South Texas Project
Units 3 and 4
Docket Nos. 52-012 and 52-013
Response to Requests for Additional Information and Submittal of Technical Report

Attached are the responses to NRC staff questions included in Request for Additional Information (RAI) letters numbered 377, 412 and 413 and supporting Technical Report WCAP-17331, Revision 2, "Structural Analysis Report for STP Units 3 & 4 Spent Fuel Storage Rack Baseline Design." These responses and Technical Report are related to Combined License Application (COLA) Part 2, Tier 2, Section 9.1, "Fuel Storage and Handling." Responses to Specific RAIs of letter 377 were previously provided by references 1, 2 and 3. This letter completes the response to the remaining RAIs in letter 377 and where indicated revises responses previously provided. This letter also completes the response to letters 412 and 413. It should be noted that the RAIs related to new fuel racks have been answered by reference to

RAI 09.01.02-2**QUESTION:**

Figure 1: Total Internal Energy vs Energy Absorbed by Fuel

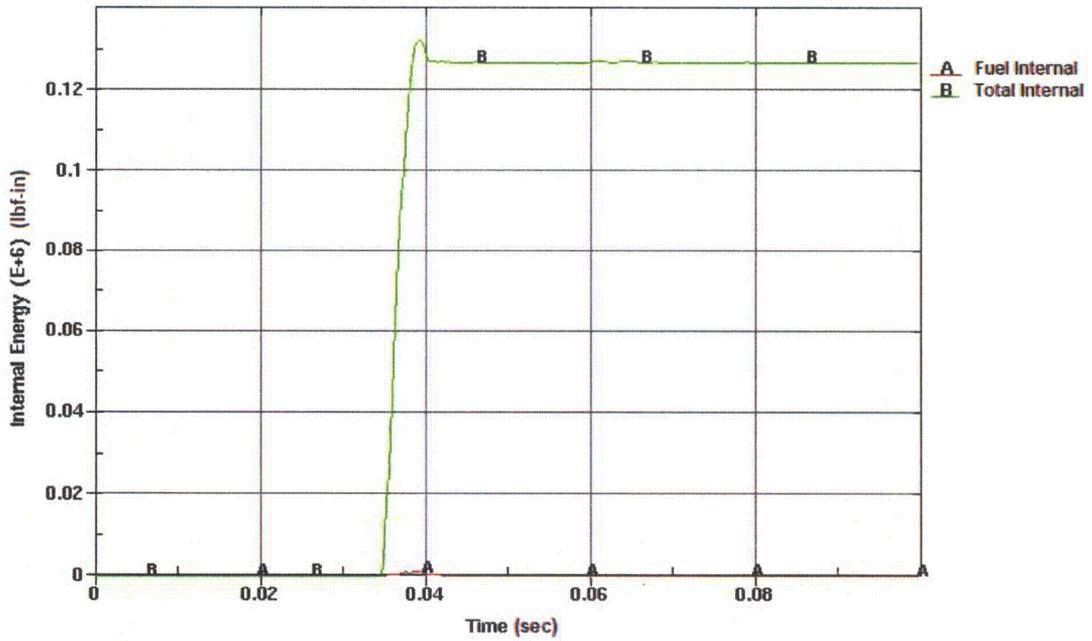
- d. Describe how the dropped fuel assembly was modeled. Is it assumed to be infinitely rigid, absorbing no energy by deformation, or is it assumed to be an elastic-plastic member, capable of absorbing energy by deformation? If the latter is assumed, provide figures showing the fuel assembly deformation for both the shallow and deep drop cases, and specify the percent of the initial potential energy that is absorbed by deformation of the fuel assembly.

- d. The fuel assembly is modeled as an effectively rigid body. That is, the fuel is represented as a meshed, deformable body; however, its elastic modulus has been set an order of magnitude higher than the elastic modulus of the impacted material, i.e., the rack cell walls and baseplate. Figure 1 shows a plot of the total internal energy of the system versus the energy absorbed by the fuel due to deformation for a deep drop case. The plot confirms that an insignificant (less than 1%) amount of energy is absorbed by the fuel model during impact.
